MIL-M-28787/57A
AMENDMENT 4
28 April 1993
SUPERSEDING
AMENDMENT 3
3 June 1985

MODULES, STANDARD ELECTRONIC

SWITCH, ANALOG, ANALOG, KEY CODE TTY

This amendment forms a part of Military Specification MIL-M-28787/57A(EC), dated 25 October 1978, and is approved for use by all Departments and Agencies of the Department of Defense.

FIGURE 1. TTY module function diagram, analog switch.

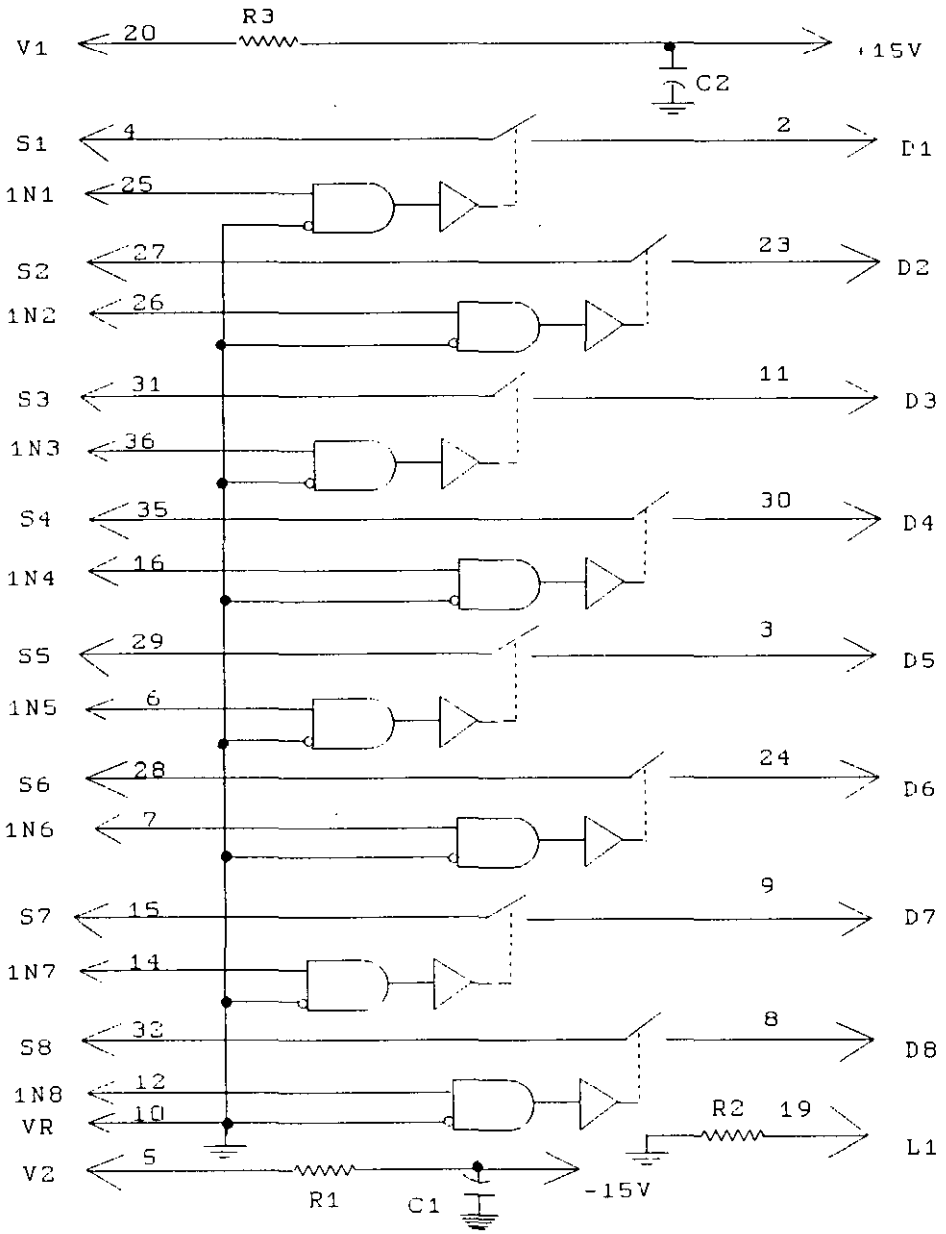
FIGURE 1: Delete and substitute new figure 1 as printed on page 4 of this amendment.

1. R1 = R3 = 100Ω.
2. R2 = 4.7 kΩ.
3. C1 = C2 = 2.2 μF.
4. The following pins are not used and each shall be isolated from all other pins: 1, 13, 17, 18, 21, 22, 33, 34, 37, 38, 39, and 40.

FIGURE 5. Analog switch feed thru and distortion test circuit for table IV.

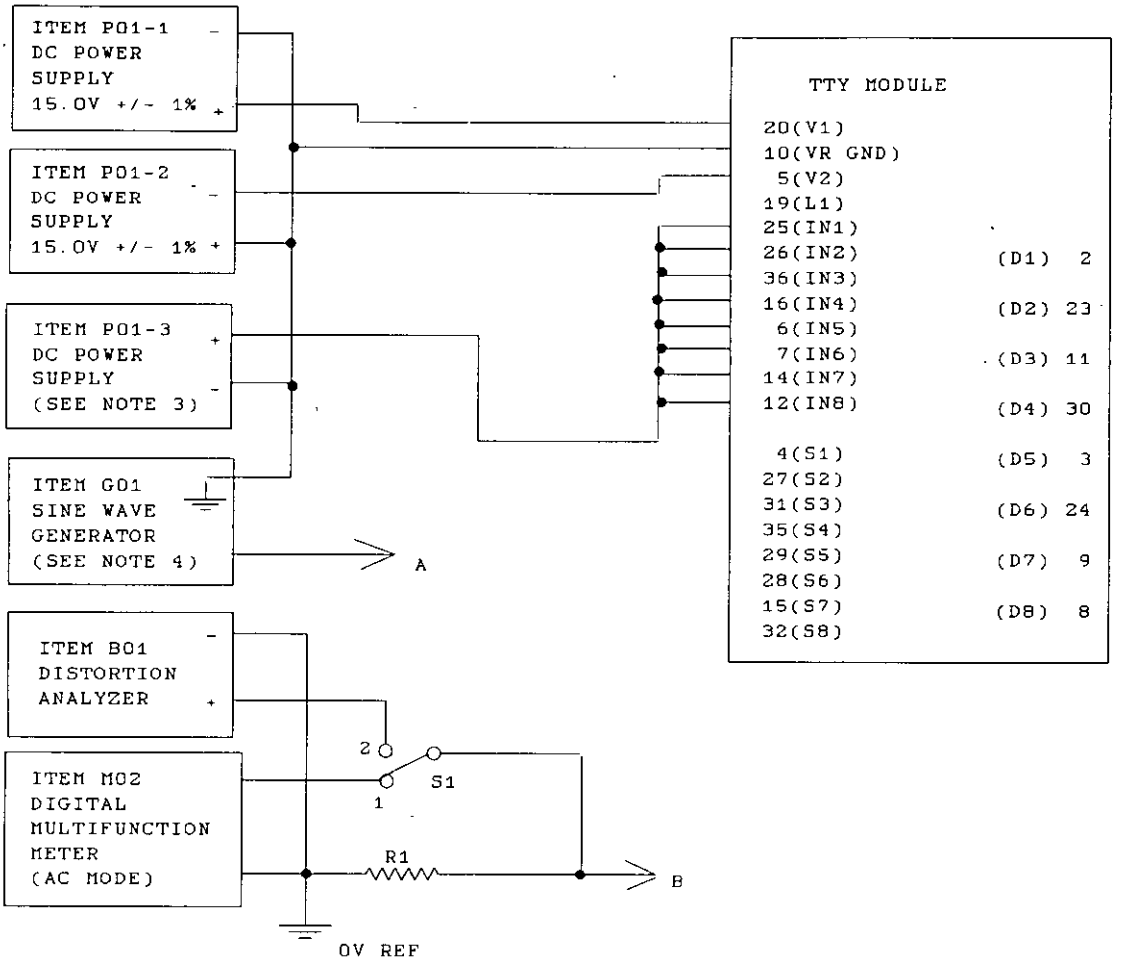
FIGURE 5: Delete and substitute new figure 5 as printed on page 5 of this amendment.

1. R1 = 4.7 kΩ ± 1%, 1/10 W.
2. S1 = SPDT switch.
3. Set item P01-3 as follows:
   a. Test conditions C1-C16 at 0.80 ± 0.01 V.
   b. Test conditions D1-D16 at 2.41 ± 0.01 V.
   c. Test conditions E1-E8 at 2.41 ± 0.01 V.
4. Set item G01 as follows:
   a. Test conditions C1-C16 at 5.0 Vrms ± 1%, 10 kHz ± 1%.
   b. Test conditions D1-D16 at 5.0 Vrms ± 1%, 10 kHz ± 1%.
   c. Test conditions E1-E8 at 4.0 Vrms ± 2%, 10 kHz ± 1%.
5. Set switch S1 as follows:
   a. Test conditions C1-C16 at position 1.
   b. Test conditions D1-D16 at position 1.
   c. Test conditions E1-E8 at position 2.

FIGURE 6. Resistance test circuit for table V.

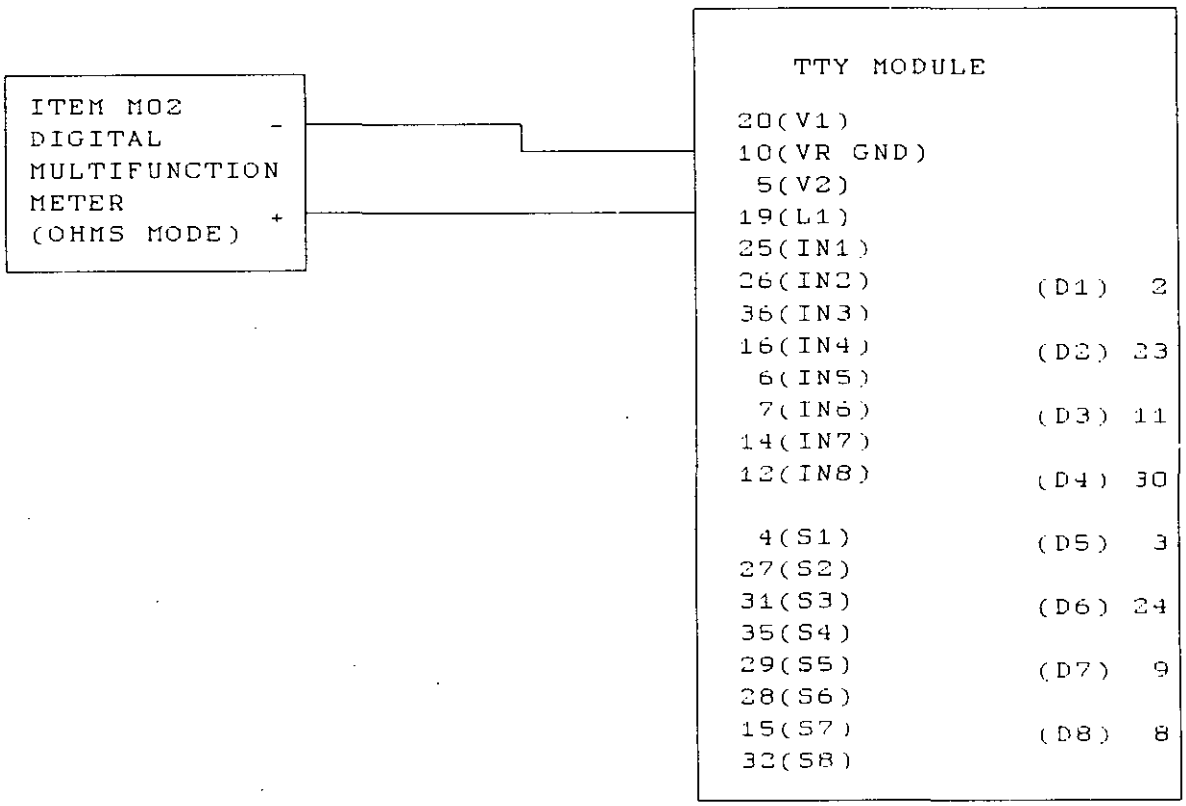
FIGURE 6: Delete and substitute new figure 6 as printed on page 6 of this amendment.

FIGURE 9. Input current test circuit for table VII.

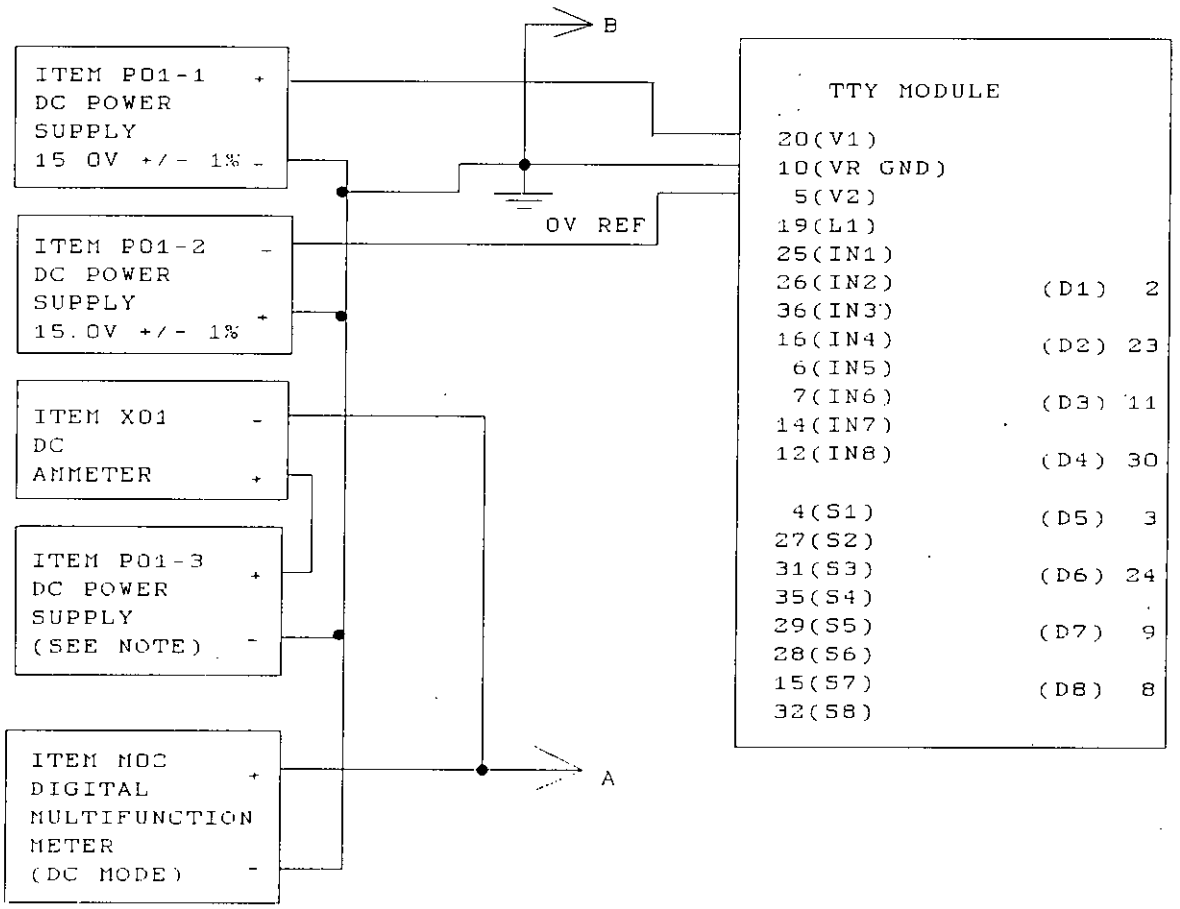
FIGURE 9: Delete and substitute new figure 9 as printed on page 7 of this amendment.

CAUTION:
Do not isolate the chassis of ammeter X01 from earth ground.

NOTE: Set item P01-3 as follows:
a. For test conditions H1-H8 at 2.41 ± 0.01 V.
b. For test conditions J1-J8 at 0.80 ± 0.01 V.

FIGURE 10. Analog switch "on" resistance test circuit for table VIII.

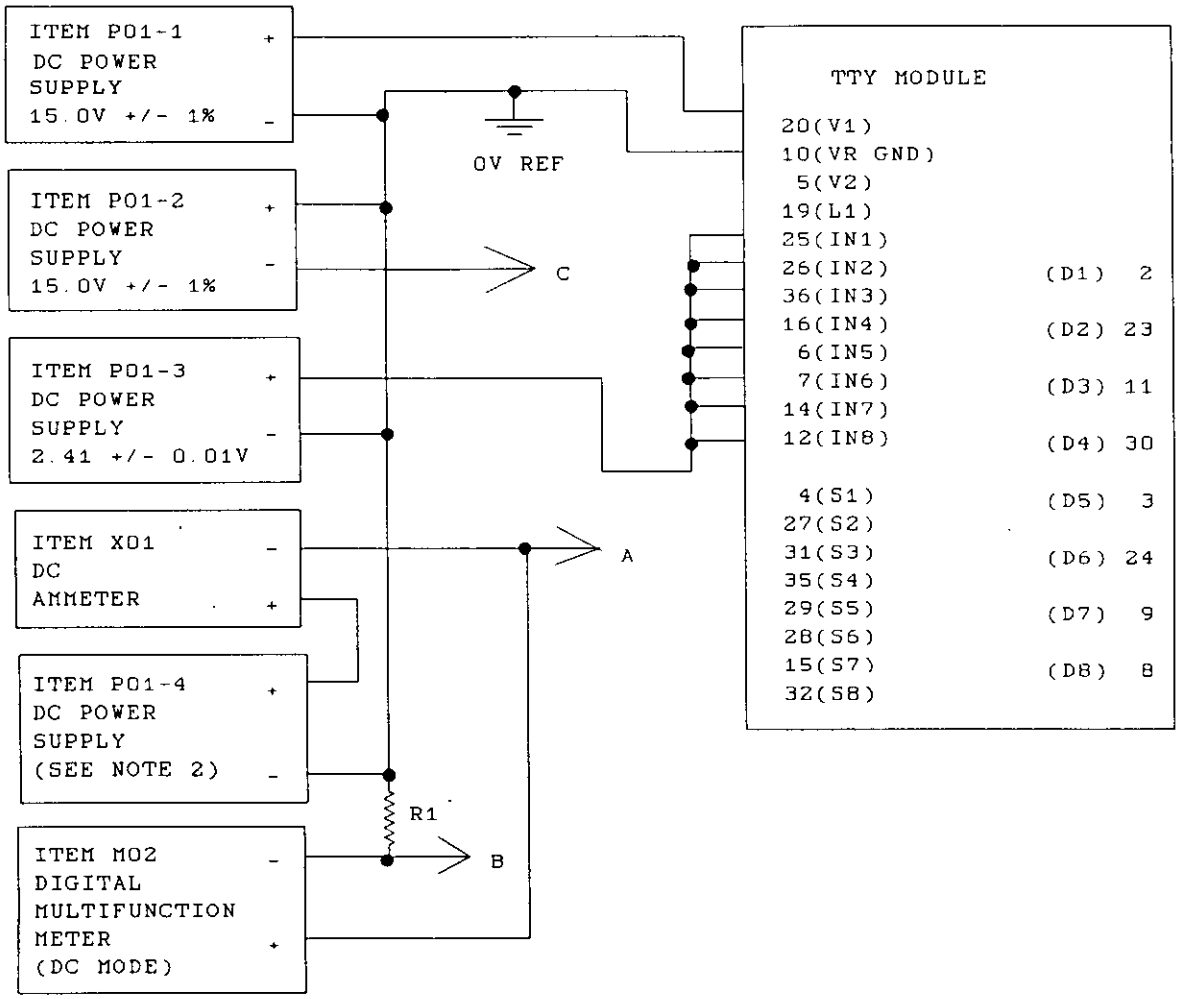
FIGURE 10: Delete and substitute new figure 10 as printed on page 8 of this amendment.

CAUTION:
Do not isolate the chassis of ammeter X01 from earth ground.

1. R1 = 7 kΩ ± 1%, 1/10 W.
2. Adjust item P01-4 to give a reading on item X01 of 1 mA. Do not exceed 10 V on item P01-4.
3. For test conditions K9-K16, connect pin 5 to ground (0 V REF).
4. The order of applying power and ground shall be ground, item P01-1, item P01-3.
